The Sir Robert Ogden Evans Property Partnership Ltd
Proposed Residential Development, Dunningley Lane, Tingley

Stage One Road Safety Audit Designer's Response

4 December 2017
Version 1.0
Issue

Problem 3.16

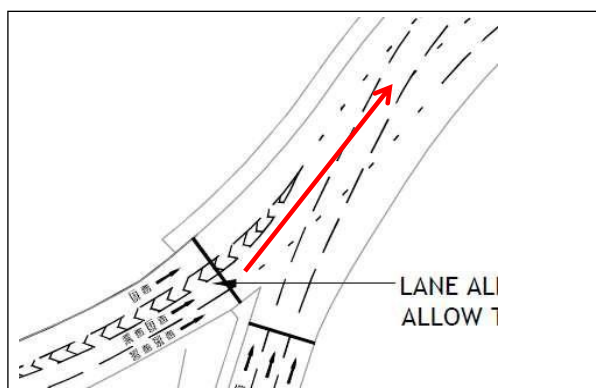
- Location:** M62 eastbound exit slip to the A653
- Summary:** Extra lane to Leeds conflicts with warning line
- Description:** The drawing provided shows two lanes of traffic to be signed from the M62 eastbound slip road towards Leeds along the A653. Drivers in the southernmost of these two lanes are separated from the nearside lane by an area of hatching so once in that lane they will not be encouraged to cross into the nearside lane as they approach the circulatory carriageway. This means however they will have to cross a section of Diagram 1004 warning line on the circulatory carriageway in order to access the A653 to Leeds. Some drivers may be reluctant to cross a warning line and may instead try to enter the nearside lane as they move into the circulatory carriageway with possible sideswipes and collisions with other vehicles already in that lane and possible injuries to vehicle occupants.

- Recommendation:** It is recommended that a section of the Diagram 1004 warning line should be removed from the circulatory carriageway in this location to avoid drivers from the M62 eastbound slip central lane having to cross it and that the lining arrangement after the stop line should be reviewed.
- Designer Response:** Recommendation accepted.
- The lane markings shown on the drawing is indicative only. The precise details of lane markings will be addressed as part of the detailed design.

Drawn by	Checked by	Date	Scale	Format
PJ	AS	2017	1:500	A1
3103	3103 SK001 024			C

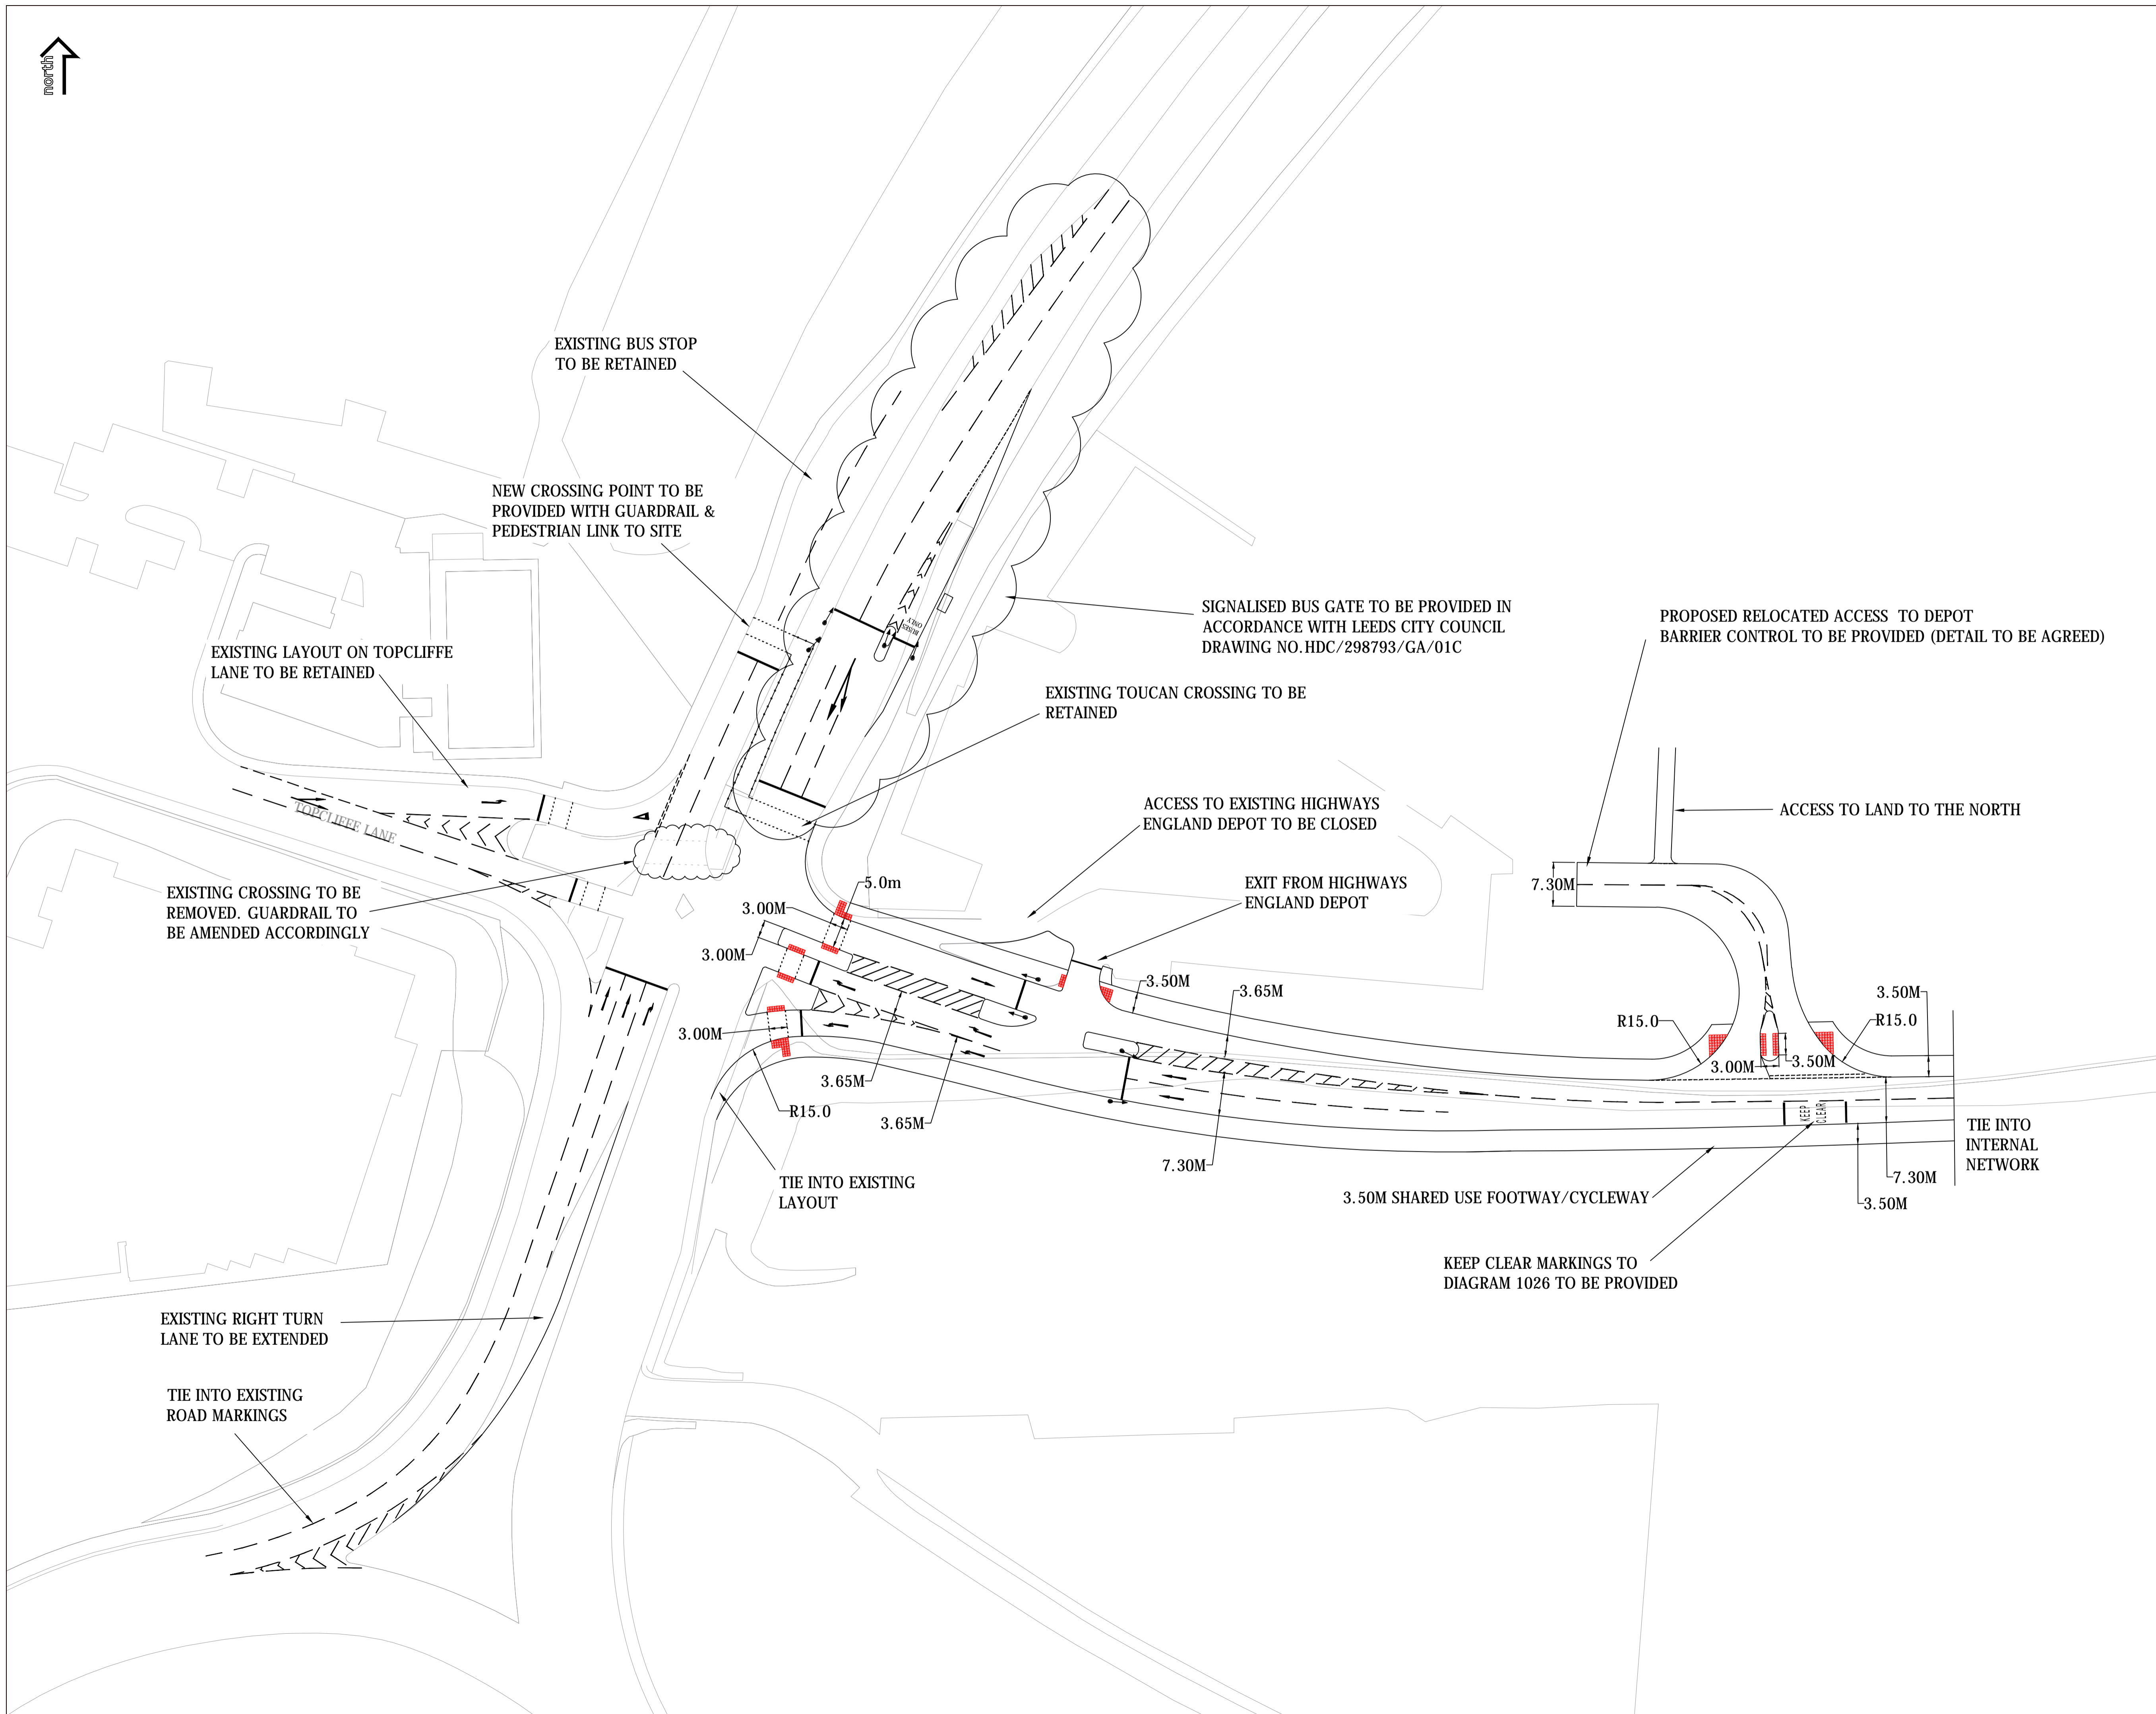
Location:	New development access junction with A653 Dewsbury Road
Summary:	Absence of stagger at pedestrian crossing
Description:	The pedestrian crossing over the proposed development (near the Highways Depot) has no stagger over two of the links. Pedestrians crossing may be tempted to cross these lanes in one single movement, not looking for vehicles turning into or out of the development.
Recommendation:	It is recommended that the northern most link is moved further into the link road to introduce a stagger.
Designer Response:	Recommendation accepted. The proposed layout has been amended accordingly and demonstrated on Fore Consulting drawing 3103/SK001/024C.

Drawn by	Checked by	Date	Scale	Format
VP	AS	30.06.2017	1:250	A1
Job Number	Drawing Number	Revision		
3103	3103 SK001 025	C

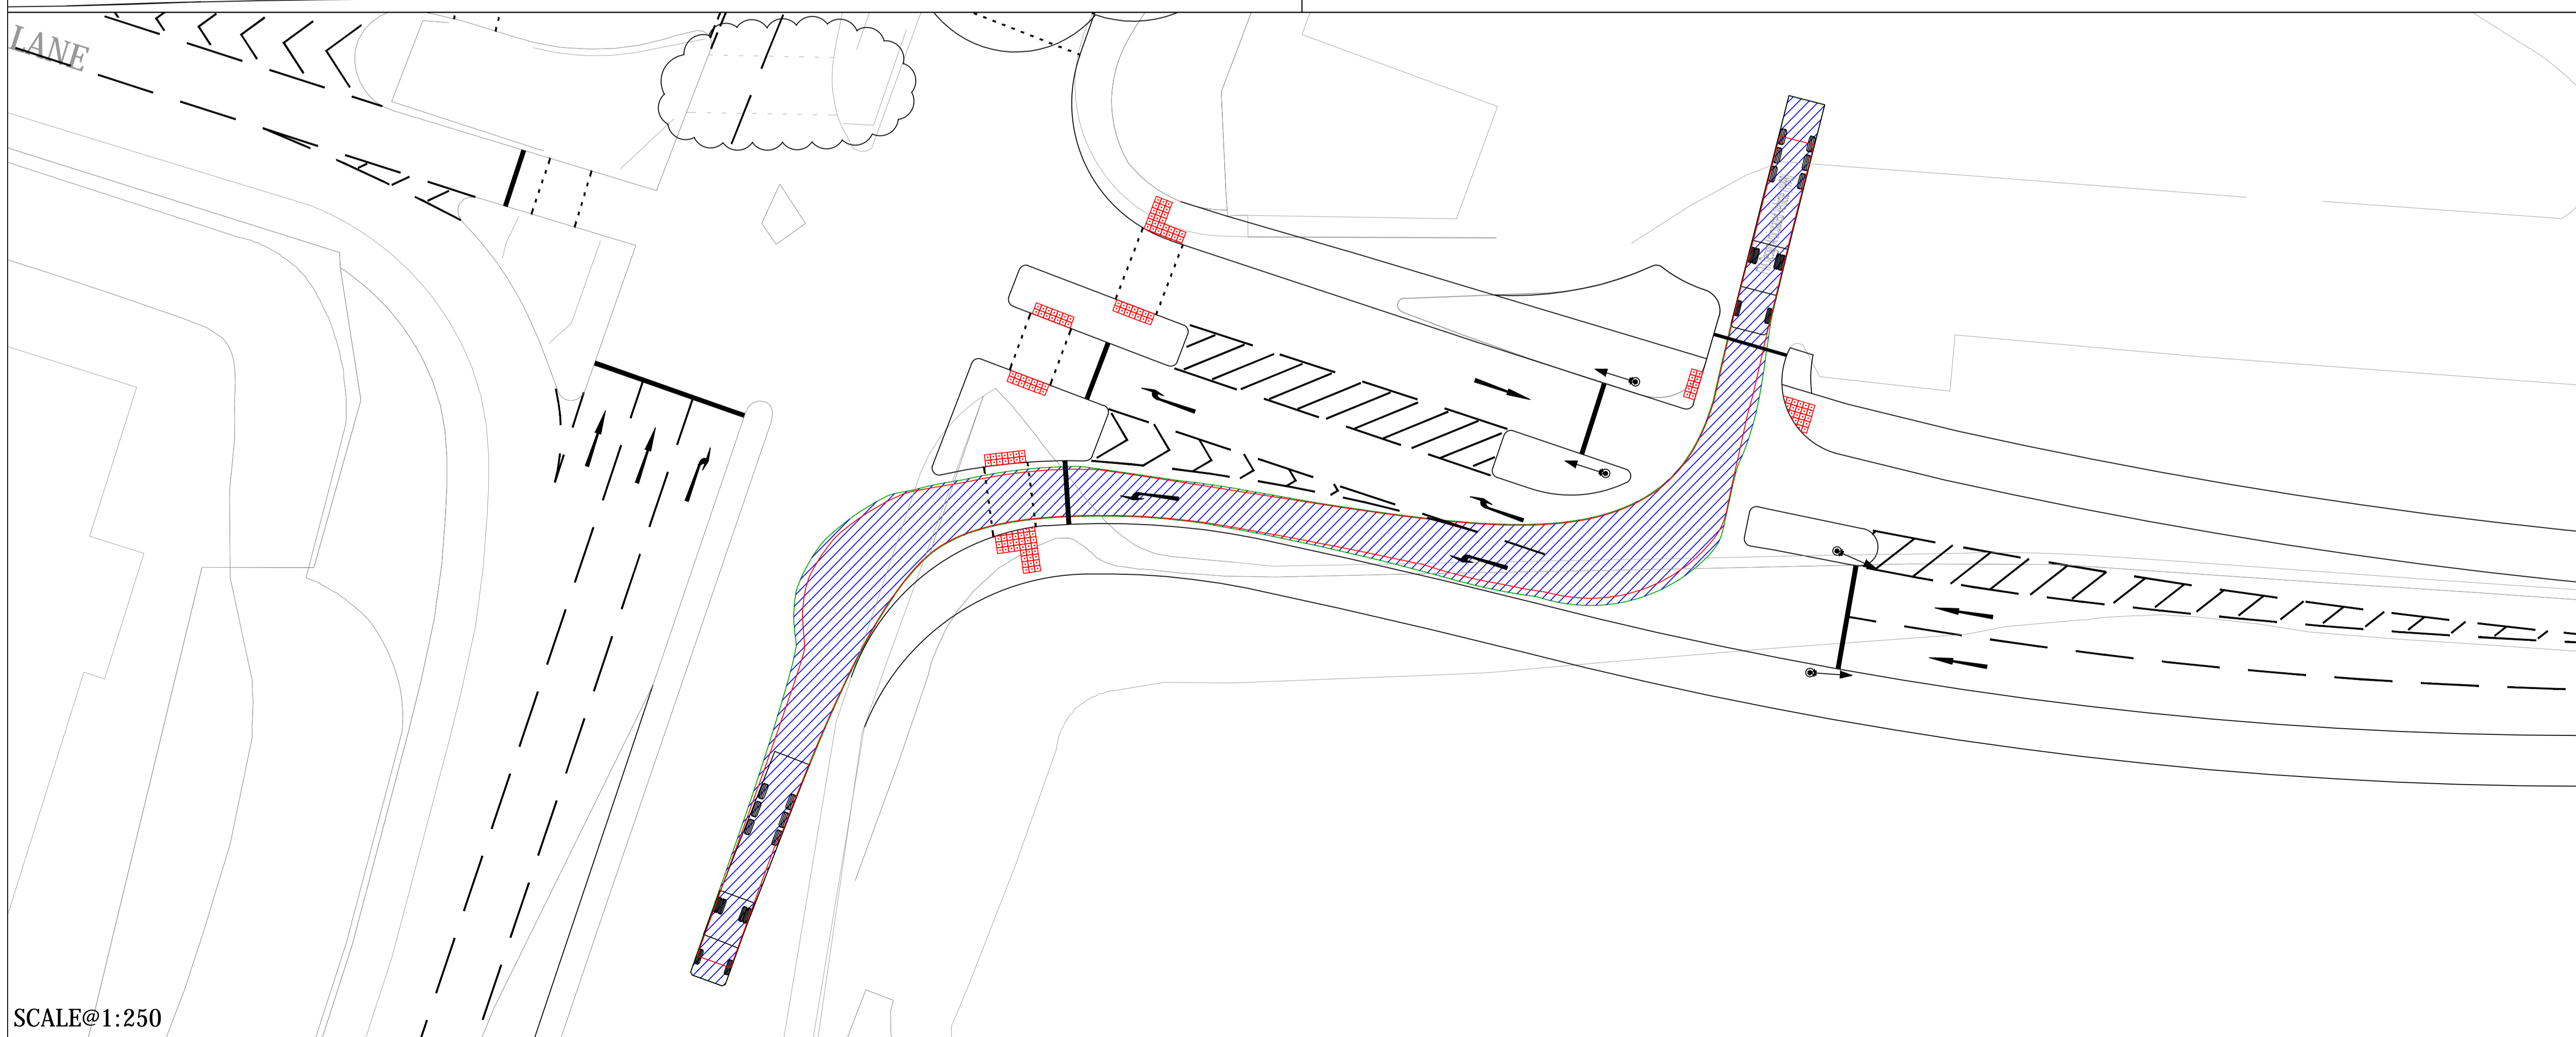
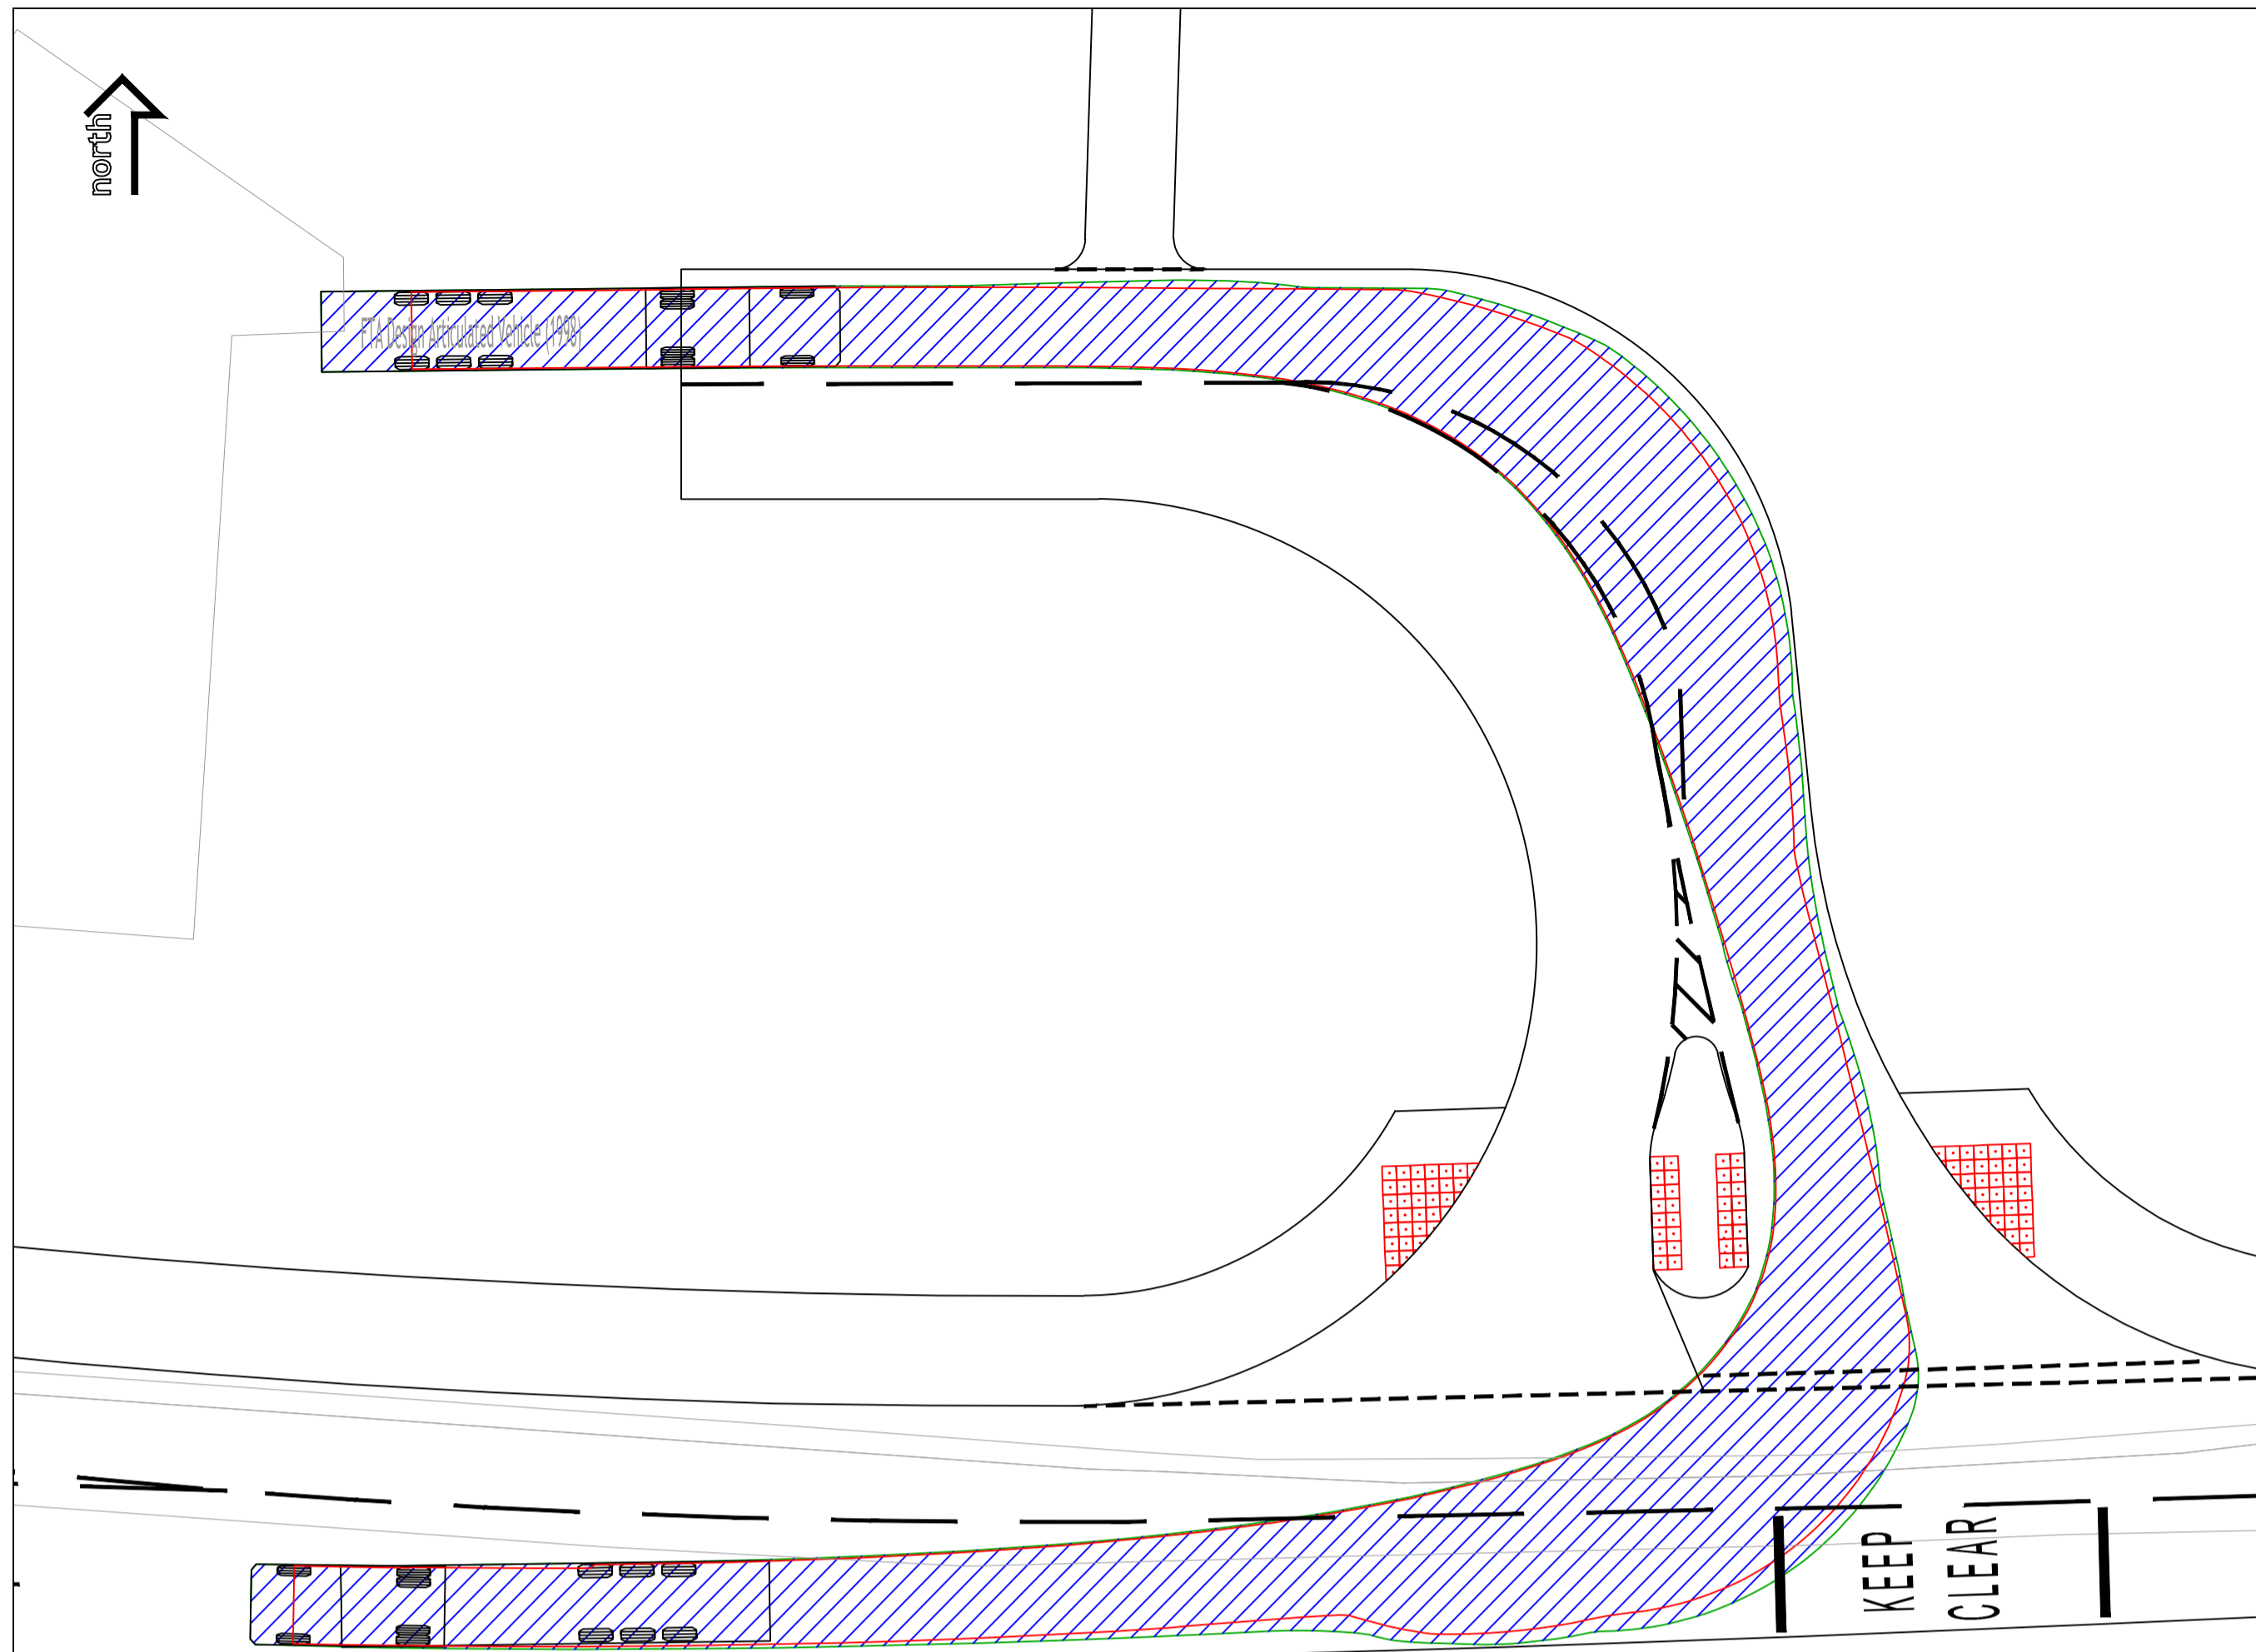
Location:	New development access junction with A653 Dewsbury Road
Summary:	Tight entry/exit to depot
Description:	The proposed eastern entry/exit from the depot from local road into depot is very tight. The swept path drawing supplied shows that opposing long vehicles could not pass each other safely on the bend. The depot access, is in constant use by traffic officers and will, at times be required to pass large or abnormal loads (periods of frequent gritting etc.), with an associated risk of head on and side swipe collisions. The access should be designed with a geometry which allows free flow of all vehicles.
Recommendation:	It is recommended that formal consultation with A-one+ / Highways England is undertaken as part of the detailed design process, to establish the exact level of usage and the required geometry.
Designer Response:	Recommendation accepted. Based on information derived from traffic surveys undertaken at the junction, movements by large vehicles are infrequent, and it is extremely unlikely that large vehicles would need to pass each other in practice. Notwithstanding this, further formal consultation with Aone+ and Highways England will be undertaken as part of the detailed design process.
